**Comments by Justin De Syllas and Annette Main, First House, Dartmouth Park Road, NW5 1SU on Application number: 2017/2381/L, Listed Building Consent and Application number: 2017/2383/P, Full Planning Permission.**

**Figure 8. Grove End House, diagrams showing the development of the design of the proposed attic storey**

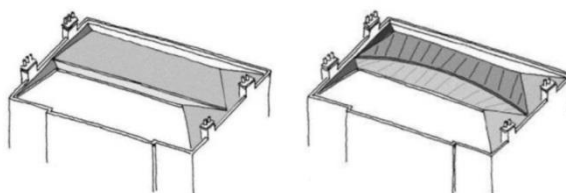
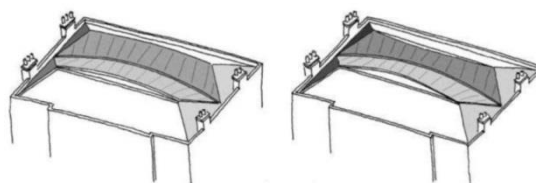
The way in which the shape of the proposed attic storey has been derived from the form of the M-form roof that once existed at second floor level is illustrated in a set of diagrams shown in the applicant's Heritage, Design and Access Statement, see Figure 8 below. These four diagrams are very clear and helpful, in so far as they illustrate the way in which the design was conceived. What the diagrams do not reveal, however, is that the M-form roof that once existed at second floor level could not simply be reproduced at third floor level because there isn't a suitable platform surrounded by parapets on which to place it.

Nor do the applicant's four diagrams tell the full story because they have not included a drawing showing the final modelling of the proposed attic storey. Despite producing an encyclopaedic Heritage, Design and Access Statement, the applicants have shown very little clear three dimensional information about the architectural form of the proposed attic extension. Given that the addition of this attic is the most significant change to the appearance of the listed building being proposed one would expect to see it better represented. In order to assist the officers and councillors assessing this application, and the other consultees, it is suggested that an accurate and detailed drawing of the attic storey seen in perspective from above should be requested from the applicants.

This would show that the final form of the attic storey bears little relation to the former roofs of Grove End House at second floor level. The final proposal is, in fact, an uncomfortable compromise between the organic forms of the attic storey proposed in the earlier, now withdrawn, planning application for this site and the historic precedent of the hipped roofs, long since lost, which once existed at second floor level.

**Figure 10.** Grove End House looking due south from the terrace of First House Dartmouth Park Road showing the impact of the proposed changes to the skyline.

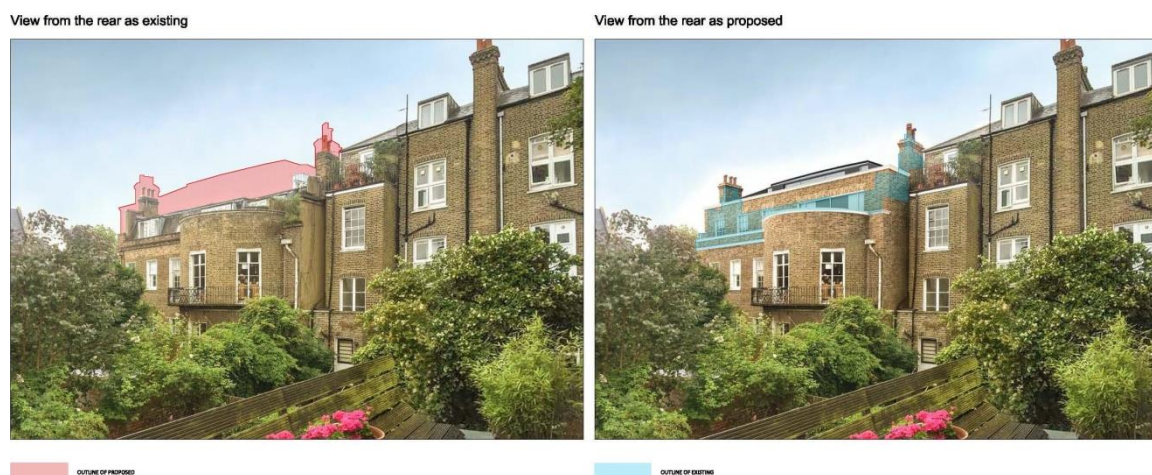
A consequence of setting the proposed additional third floor back from the front of the building, in order to make it less visible from Highgate Road, is that it would be very visible from the properties behind Grove End House on Chetwynd and Dartmouth Park Roads, increasing the overlooking and overshadowing of the gardens behind the houses of Chetwynd Villas and the windows of First House and Lamorna on Dartmouth Park Road. The site plan shows that Grove End House lies directly to the South of First House on Dartmouth Park Road. First House is already very overshadowed, and the creation of an additional floor and the raising of the second floor rear elevation of Grove End House would cut out a considerable amount of the existing sunlight received by First House in the middle of the day in winter. In addition the proposed kitchen/dining room of the proposed attic extension on Flat 6 would look straight into the living room of First House, see Figure 10 below.
